UNITED STATES
NUCLEAR REGULATORY COMMISSION

FROM: F. Robert Cook, Senior On-Site License
Representative, Basalt Waste Isolation
Project (BWIP)

SUBJECT: OBSERVATIONS, COMMENTS AND RECOMMENDATIONS
FOR THE PERIOD JUNE 14 TO JULY 18, 1986

BWIP COPPER MONOLITH WASTE PACKAGE CROSS-SECTION

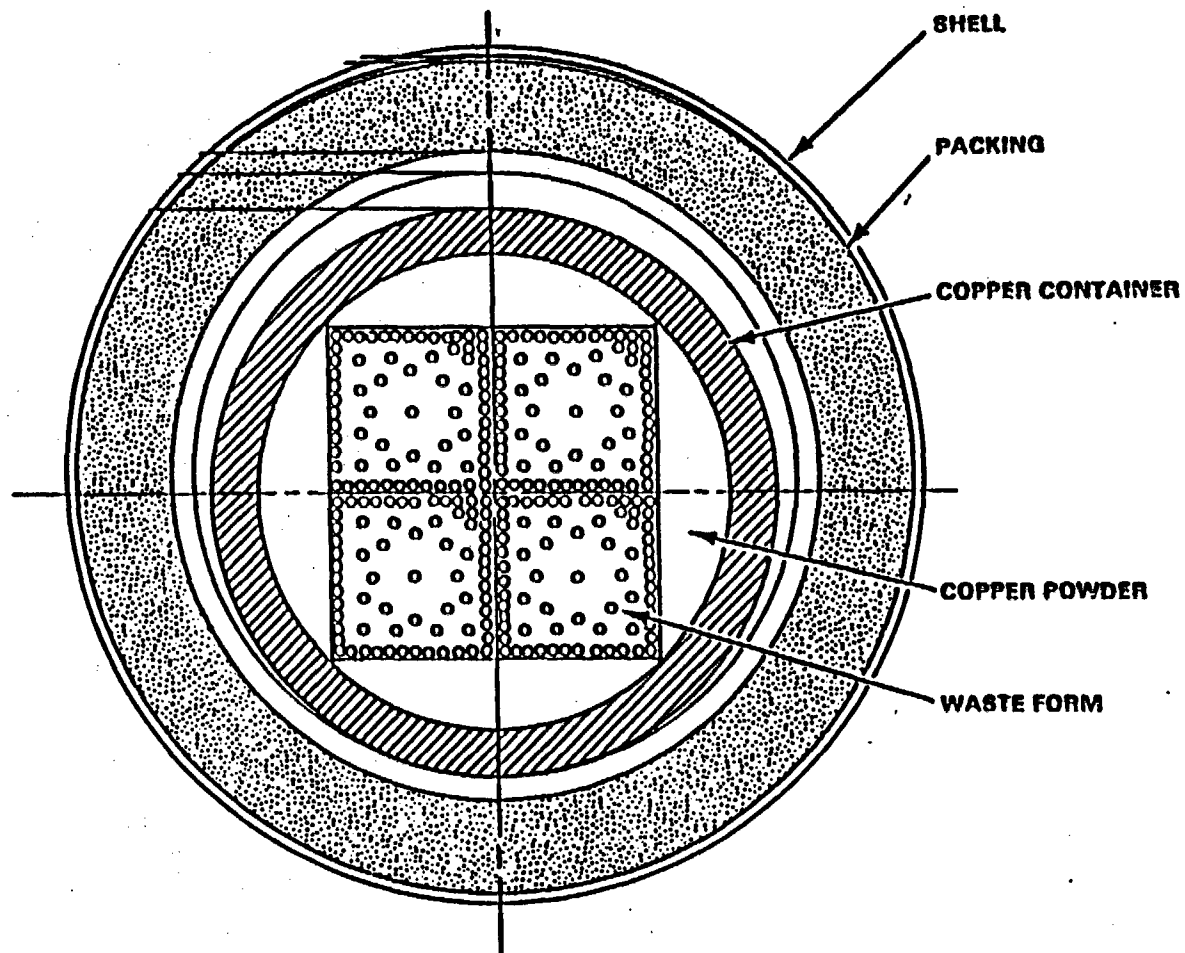
a. BWIP is considering a second waste package concept which includes a copper monolith to provide corrosion protection and restraint necessary to withstand external loads. Attachment A is a sketch of this concept.
